Title of Change:	Package Polyimide Tape Change
Effective date:	27 Nov 2019
Contact information:	Contact your local ON Semiconductor Sales Office or LengKian.See@onsemi.com
Type of notification:	This Product Bulletin is for notification purposes only. ON Semiconductor will proceed with implementation of this change upon publication of this Product Bulletin.
Change Category:	Assembly Change
Change Sub-Category(s):	Material Change

SOIC-5 Optocoupler PI Tape Qualification

Description of Change (From) :

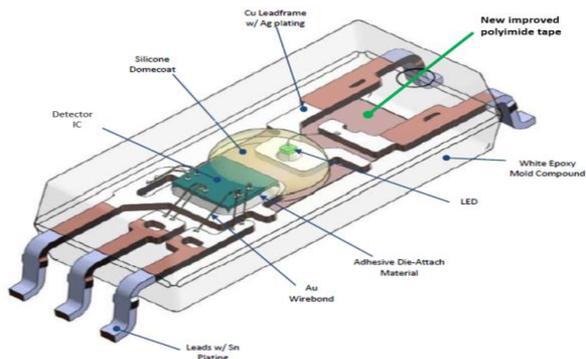
Type A polyimide tape within the package.

A new improved type B polyimide tape within the package.

The identified change will improve the reliability and robustness of the products.
